# SERVICE BULLETIN

BT18-008

## 2018 LEAF; FRONT DOOR WILL NOT OPEN

**APPLIED VEHICLES:** 2018 LEAF (ZE1)

Figure 1

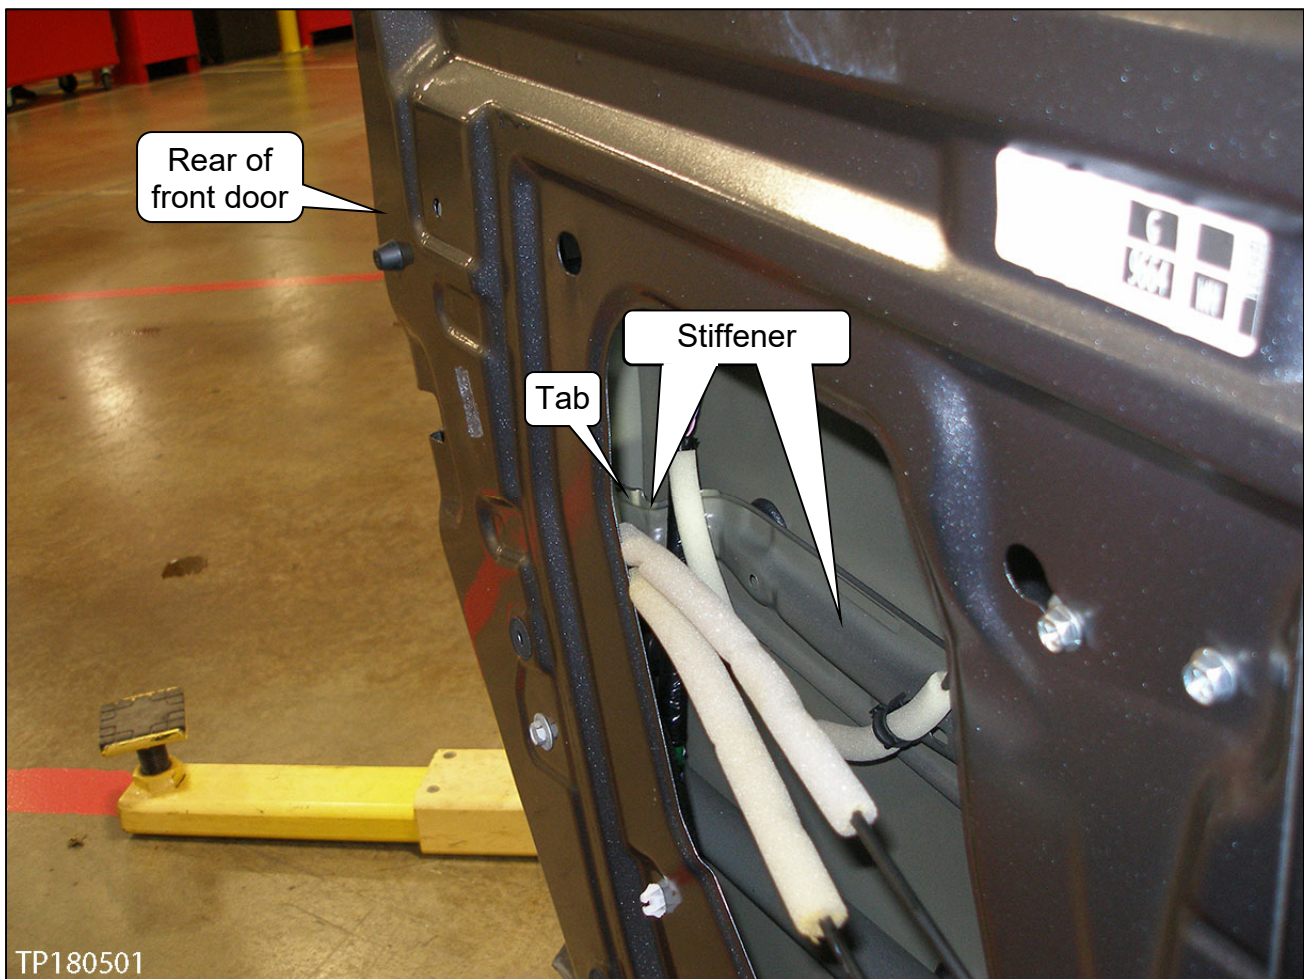
1. Remove the front door finisher of the affected door.
    - Refer to the Electronic Service Manual (ESM), section BODY INTERIOR-INTERIOR-INTERIOR-REMOVAL AND INSTALLATION-FRONT DOOR FINISHER for front door finisher removal.
- NOTE:** It may be intermittent that the door will not open. Attempt to open the door multiple times with both handles. If the door does not open normally, follow normal repair procedures for consequential damage during front door finisher removal (see Claims Information).
2. Connect the power window switch, and then close (roll up) the door glass.
  3. Access the tab stiffener and door latch lever.
    - Refer to Figure 1 below, and Figure 2 on the next page.

Figure 3

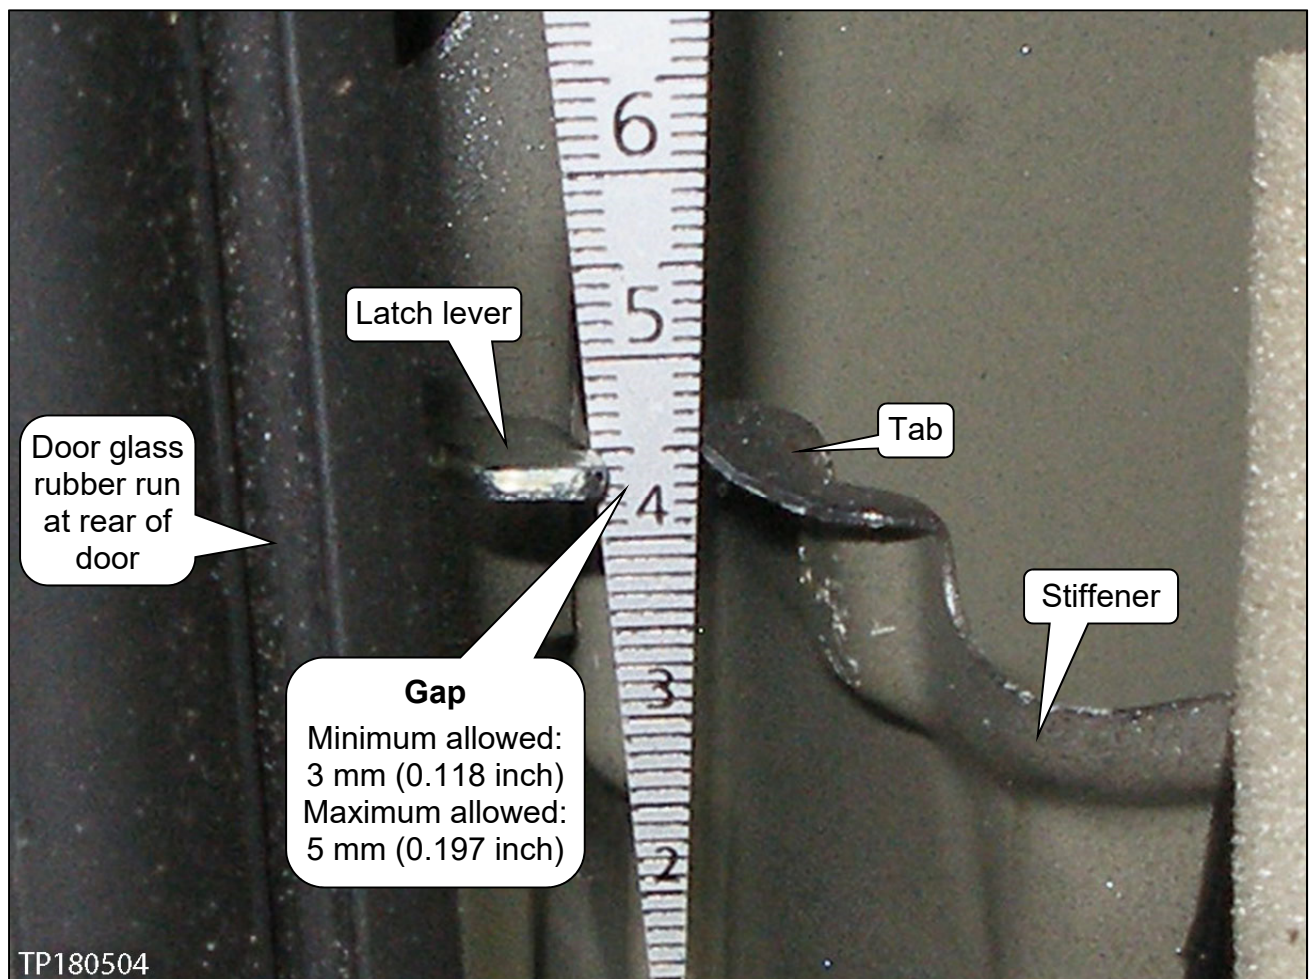
5. With the lever and stiffener tab still level with each other, inspect the gap between the latch lever and stiffener tab.

- Lever-to-door stiffener gap:

Minimum 3 mm (0.118 inch), maximum 5 mm (0.197 inch)

Figure 4

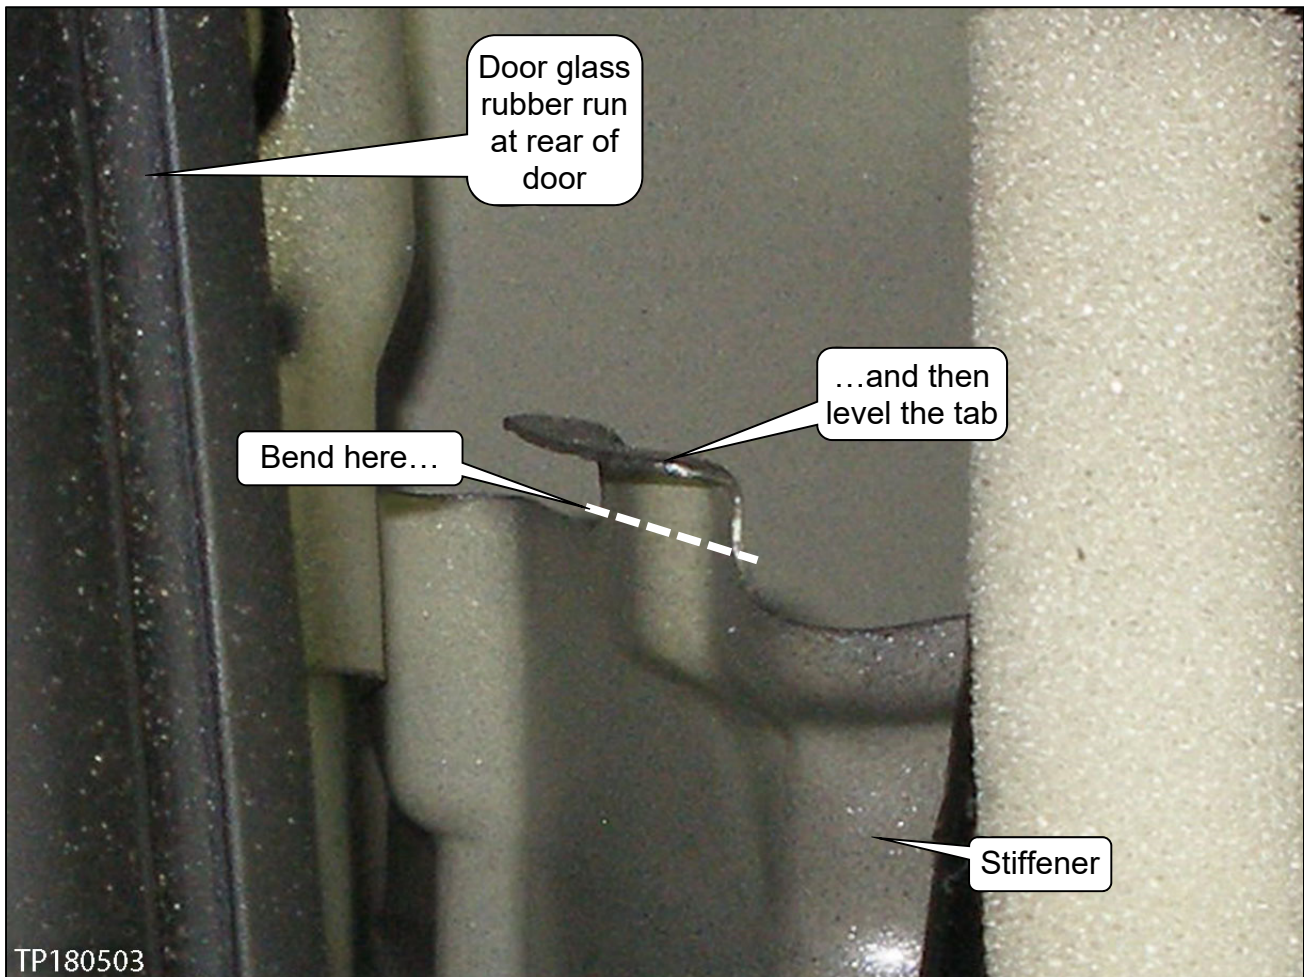
6. If the gap is not within specifications, adjust the stiffener tab to widen the gap.
- Using a suitable pair of pliers, adjust the gap by bending the stiffener tab horizontally along the dashed line (see Figure 4).
  - After adjusting the gap, adjust the tab as necessary to a level position (see Figure 4).
- CAUTION:** Do not adjust the gap by bending the stiffener tab up or down only.
